PROJECT :	BKK2	R.F.I. NO. :	523213-01-RFI-AR-0018
TO :	CTA	ATTENTION :	CTA
SUBMITTED DATE:	13-Jan-26	NEED REPLY BY DATE :	20-Jan-26

SUBJECT : Request for Information - Request for Information - Confirm Wall Alignment from IFC and TTI Model, which model we should use?

IFC Drawing

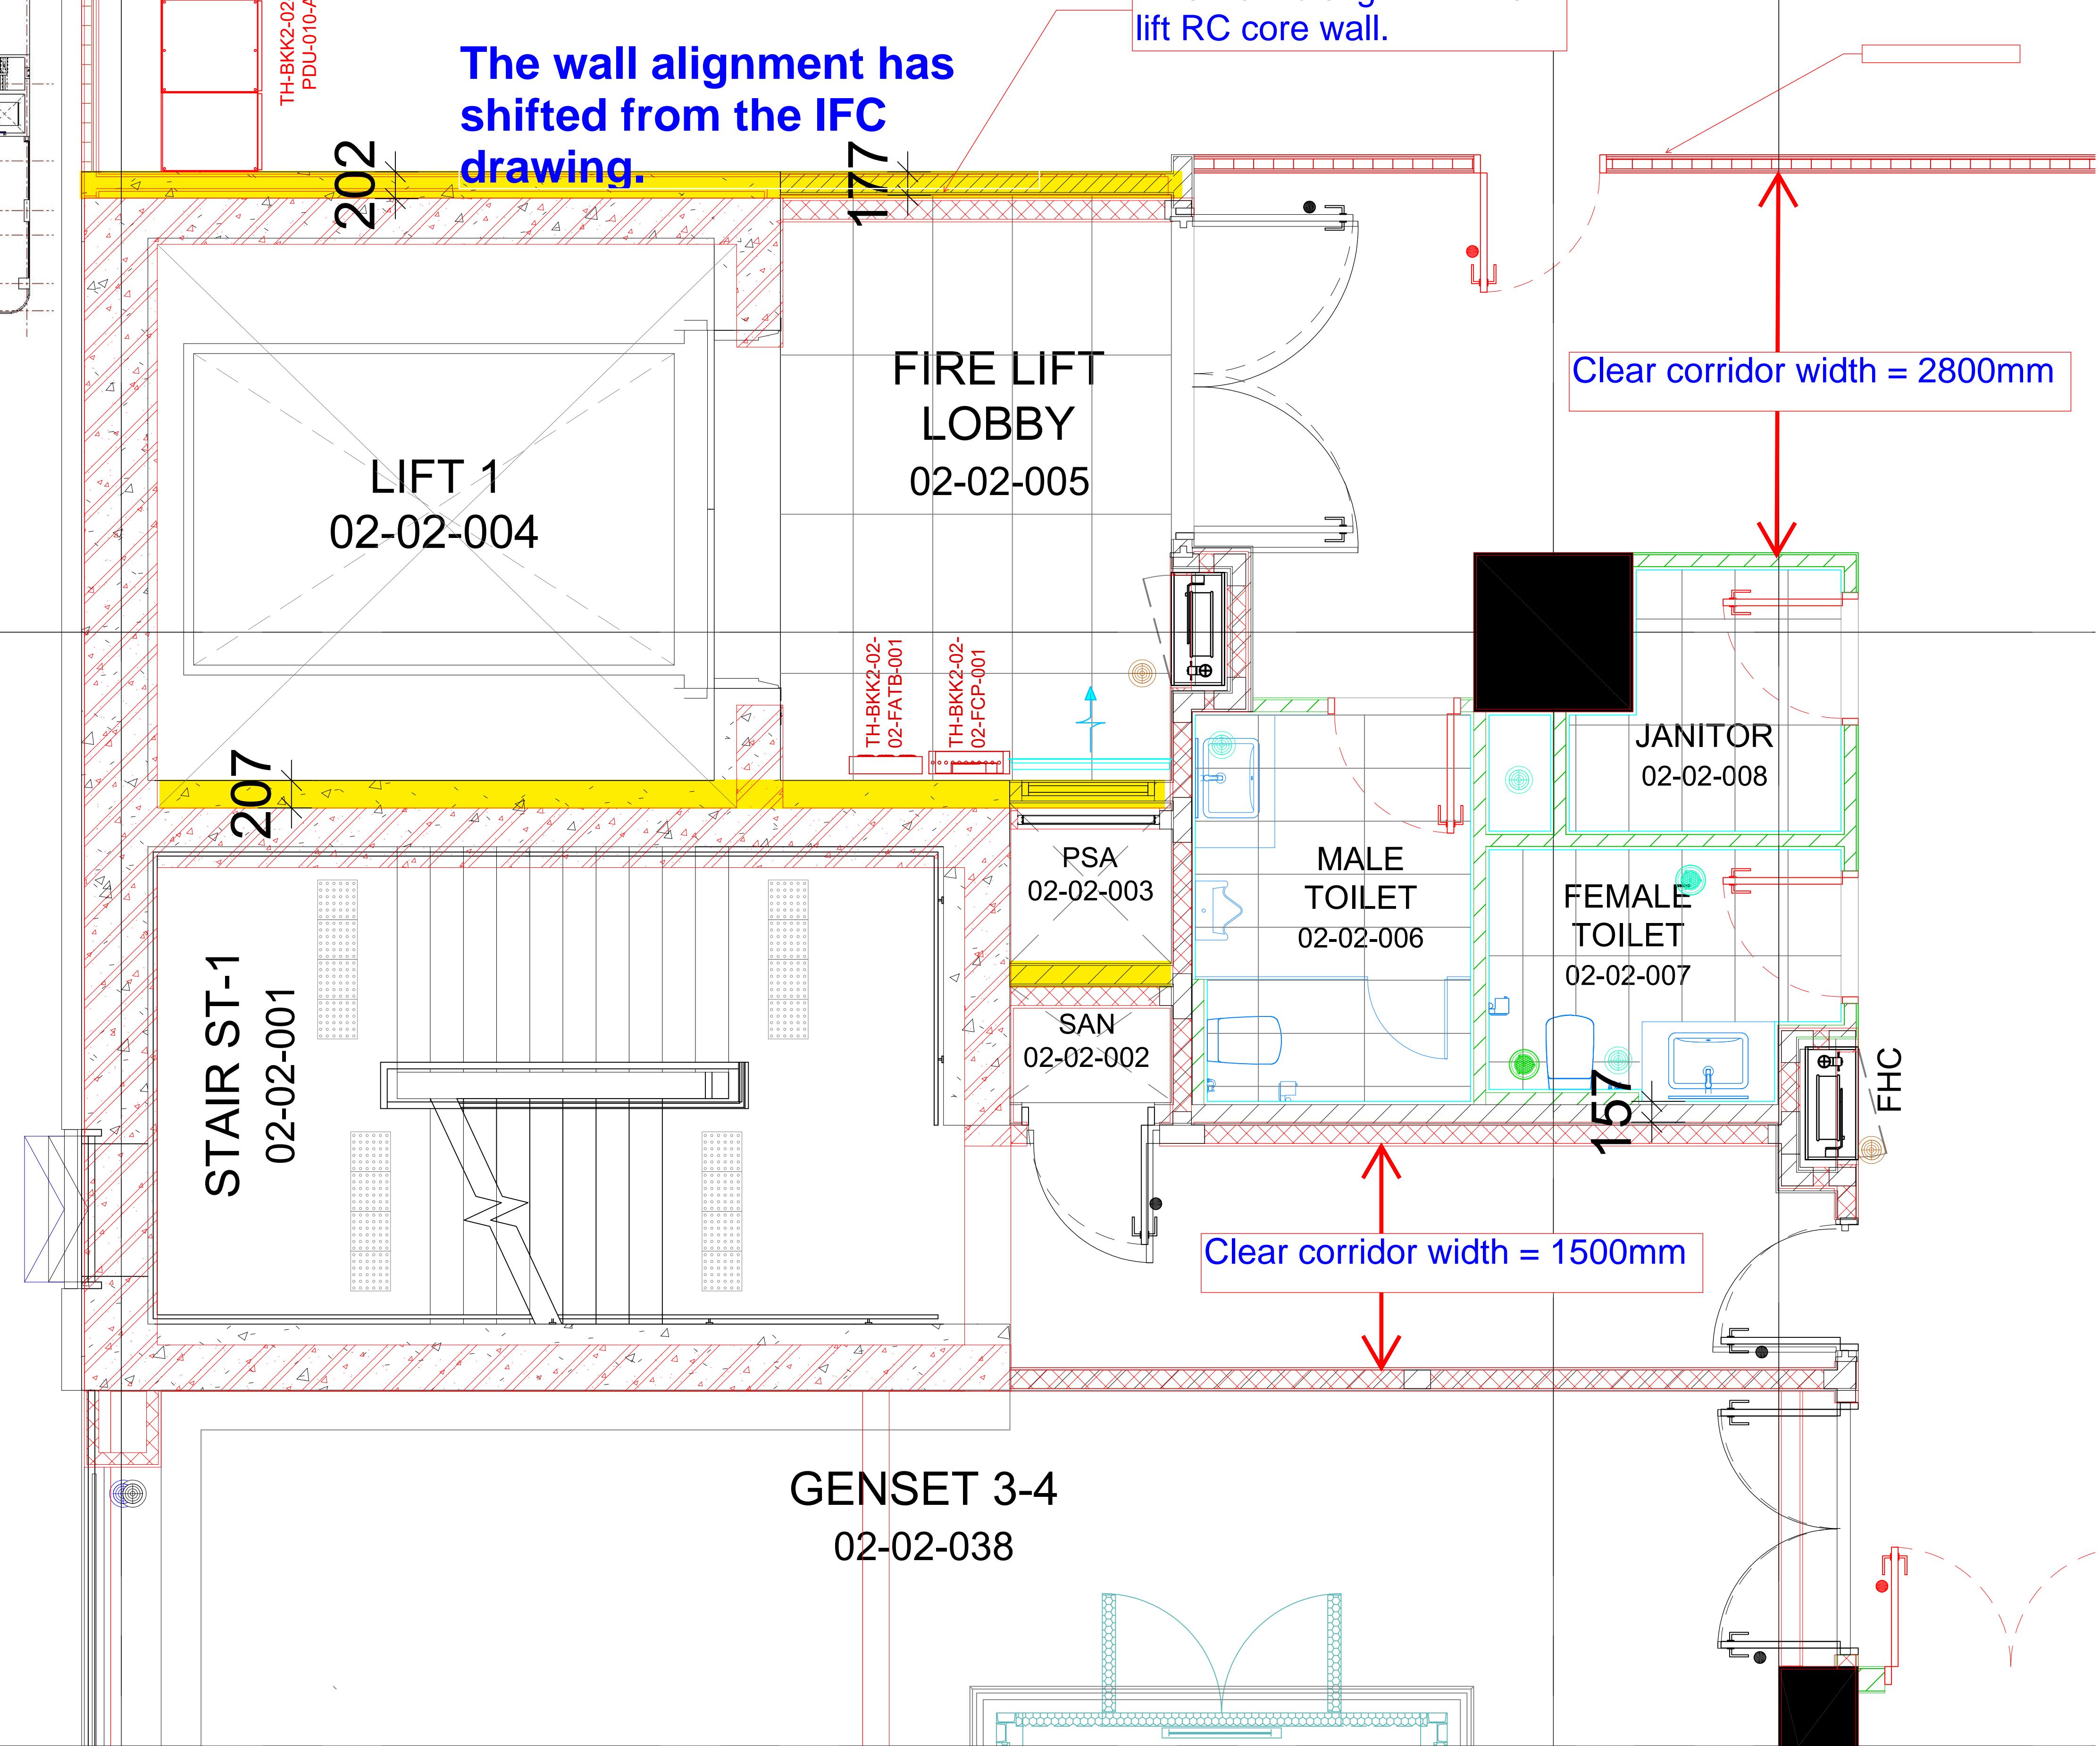
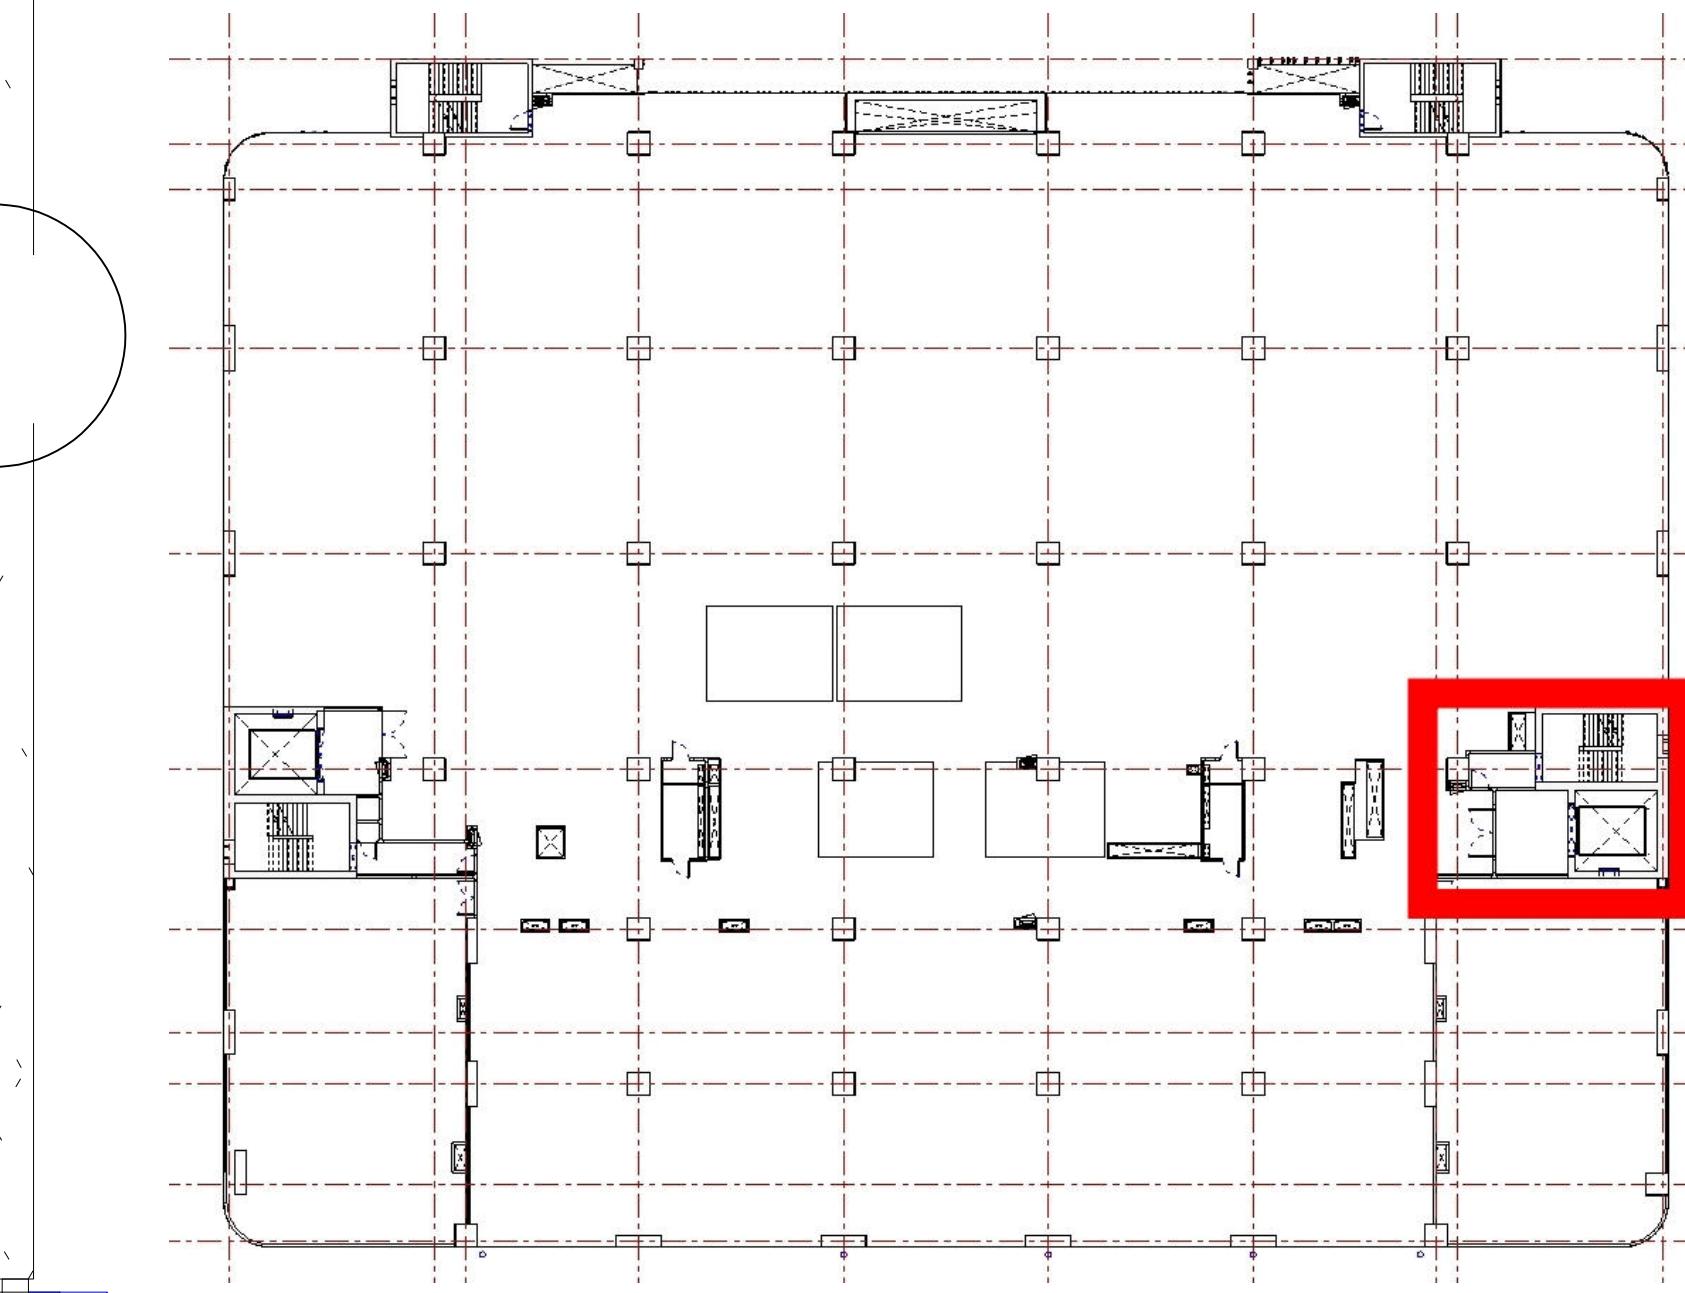
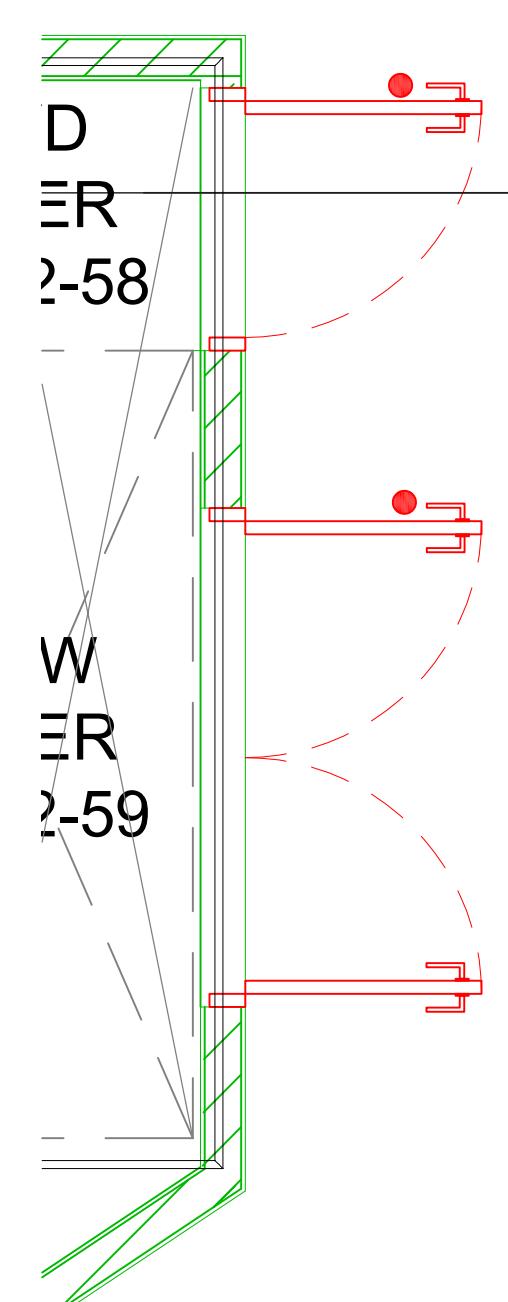
Regarding the alignment of the wall between IFC and TTI model is not the same. Gaa would like to confirm which model we should use?

The wall alignment has shifted from
the IFC drawing.

GAA are to coordinate and complete the connection between the scope of
TTI and GAA as per discussions at a meeting the 14th of January 2026. During
this meeting it was confirmed on how GAA were to proceed for each item
highlighted below.

SLA: Please refer to the notes in the attached markup.

Data hall must be maintained.
The spare riser wall to match RC core wall.
